December 15, 2011  
E-31647

Subject: Initial Application for Amendment 3 to the Standardized Advanced NUHOMS®  
Certificate of Compliance No. 1029, Docket No. 72-1029

Amendment 3 adds the NUHOMS® 32PTH2 system, which consists of a new transportable Dry Shielded Canister (DSC) designated the 32PTH2, stored in a modified version of the currently licensed Advanced NUHOMS® AHSM horizontal storage module, designated the AHSM-HS.

**Figure 4-1 Minimum Spacer Disc Ligament Widths for 24PT1 and 24PT4-DSCs**

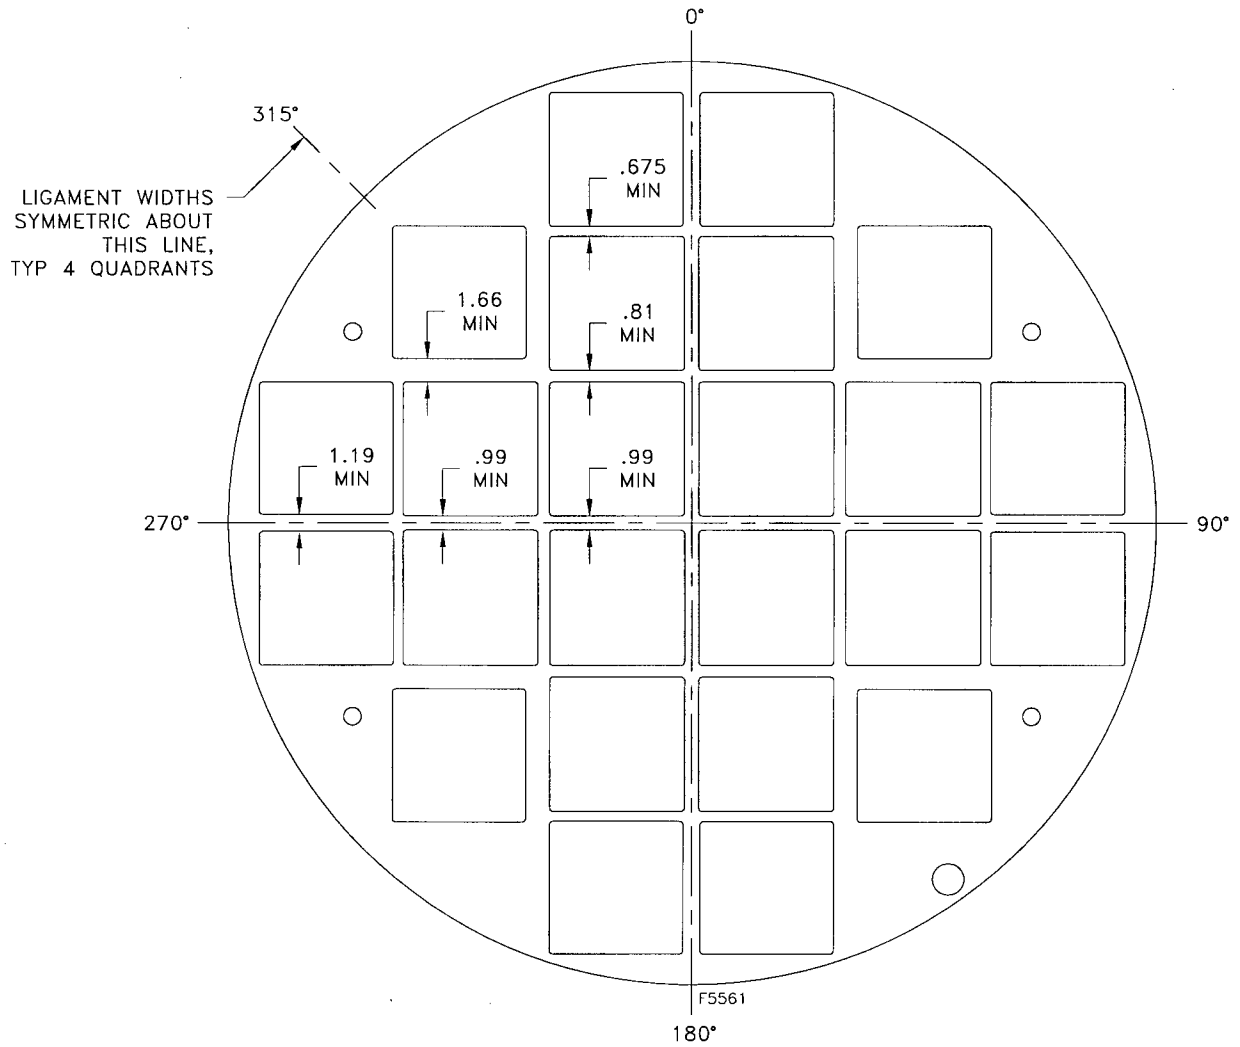
4.2.3	Added discussion regarding 32PTH2 DSC basket types and requirements for neutron absorbers.
4.2.5	Added information regarding the 32PTH2 DSC not requiring fuel spacers.
Figure 4-1	Added an explanatory note regarding ligament width dimensions, and expanded the figure title to indicate applicability to the 24PT1 and 24PT4-DSCs.

The canister flux trap configuration is defined by the spacer disc ligament width dimensions. Figure 4-1 (applicable to 24PT1-DSC and 24PT4-DSC) shows the location and dimensions of the ligaments (the dimensions shown in the one quadrant are applicable to all four quadrants).
